DEPARTMENT OF DEVELOPMENT SERVICES – PLANNING DIVISION
REPORT: Firehouse Fence Deviation at 25 Blue Hills Avenue
 for consideration May 24, 2022

PROJECT: Blue Hills Fire Station Fence Deviation
 25 Blue Hills Avenue
 PARCEL ID: 175-187-039
 P&Z-COMM-2022-0613

TYPE: Request for Special Permit for a Site Plan, pursuant to Section 1.3.4 and Section 6.13.5, including the installation of an 8’ chain link fence with privacy slats, where only 4’ is permitted in the front yard and chain link is otherwise not permitted.

Figure 1. Plan approved in 1988 showing the fuel tank, pump and 8' chain link fencing – Smith Edwards Architects 1988

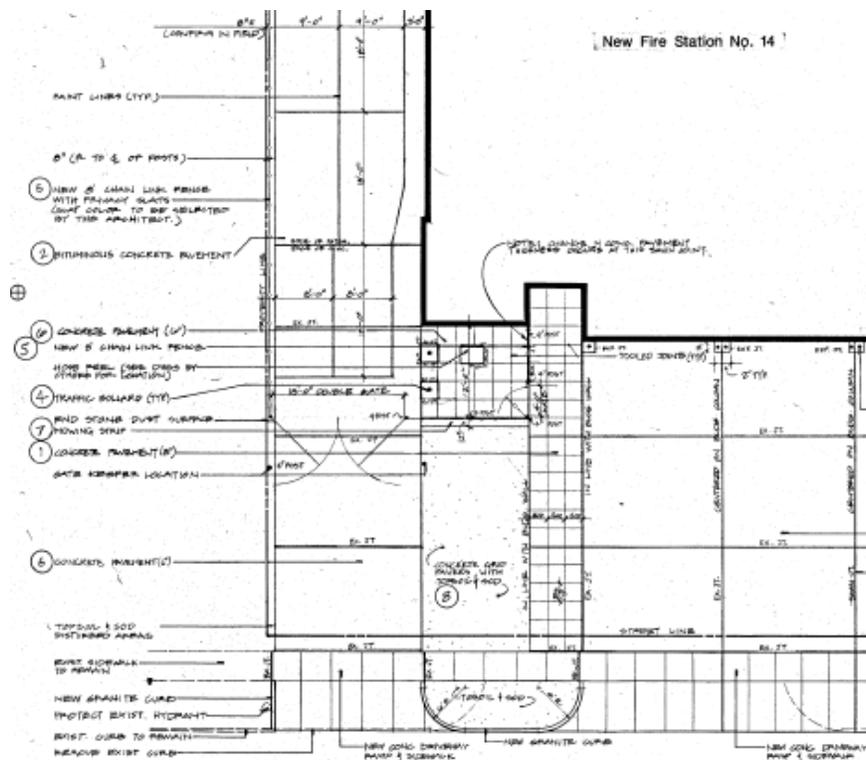
The proposed fencing is in many ways a direct replacement as well. The existing nonconforming 8' high, chain link fencing with privacy slats was approved in 1988 and has the same nonconforming rights as the fuel pump and tank. However, the proposed plan would move the fencing ~9' towards the right-of-way. Section 1.5.4 of the Regulations states generally that no non-conforming structure may be moved. The intent of this plan to move the fencing triggers the requirement that the relocated fencing come into compliance with the current regulations.

Figure 4. Site plan excerpt showing location of proposed fencing highlighted – Freeman Companies 2022

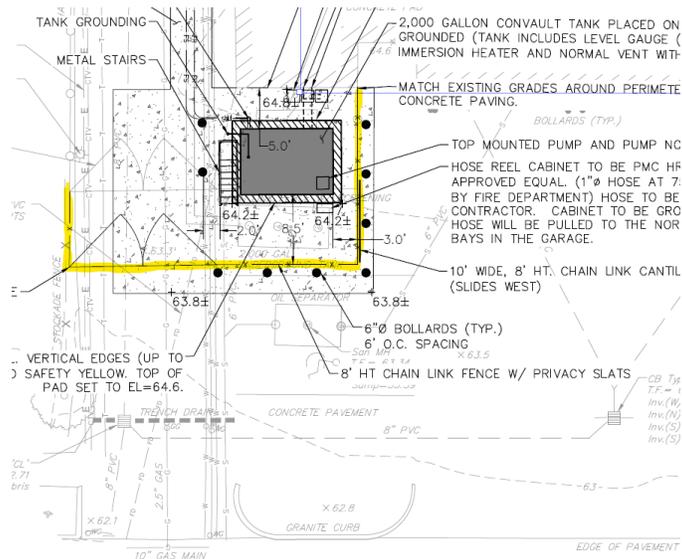
Section 6.12 "Screening of Necessary Appurtenances" requires that large accessory mechanical equipment, such as a fuel tank, be fenced with opaque wood or masonry of a height equal to the equipment, on all sides facing a right-of-way. In this case, because the fuel tank and pump are approximately 7.5' tall, Section 6.12 would require a fence at the proposed height and opacity. On its face this is a justification for this part of the deviation. However, staff find that chain link fencing with privacy slats is not consistent with the intent of the regulations as it relates to design using high quality materials for improved relationship of the pedestrian to the built environment. Further, accessory utility structures are generally required to be located in the rear or internal side yards. The nonconforming location of this accessory utility structure makes the screening for this structure more visible and of more importance than most screen fences. Staff recommend a masonry wall designed to emulate the aesthetic of the primary structure be used to screen the fuel tank. A masonry screen wall would provide an inflammable, appropriate façade for the nonconforming accessory utility structure. It would be located ~22' from the sidewalk, still providing for visibility. The masonry alternative would also satisfy many of the same justifications used by the Department of Public Works (DPW) and the Fire Marshall for the chain link fencing such as the safety, security and level of flammability of the proposed screen fence. The wall could be softened with a planting bed in front of it.

Included in the ~30' span of fencing under review is the vehicle gate which encloses an area that is used for on-site parking. This gate does not directly obscure the accessory utility structure and is therefore not subject to the additional height and opacity provision of Section 6.12 "Screening of Necessary Appurtenances". The standard requirements of the regulations permit fencing made of wood, metal (non-chain link) or

masonry in the front yard with a maximum height of 4' and a minimum transparency of 50%. The applicant has stated that the position of the gate is important to the ease of access to the fuel pump. Staff find that the use of an 8' fence for the sole purpose of securing a parking area is incompatible with the scale of the N-2-3 district. While, staff recommend allowing the height deviation to continue across the whole 30' span for overall cohesion along the facade, staff also recommend that the gate be constructed using a higher quality material (such as metal) and in a way that meets the minimum transparency requirement. It should also be noted that parking is not permitted forward of the building. Moving this gate will have the effect of expanding the enclosed parking area. Staff recommend a condition of approval that the area within the enclosure that is forward of the building remain free and clear of parked vehicles.

1. The chain link fence shall be able to be replaced at 8' provided that the replacement fence is a masonry wall and/or other high quality material that meets the intent of Section 6.12.
2. The chain link gate shall be able to be replaced at 8' provided that the replacement fence meets the transparency and material requirements of Section 6.13.3.
3. There shall be no parking forward of the building face. The enclosed front yard area shall be maintained free and clear of parked vehicles.
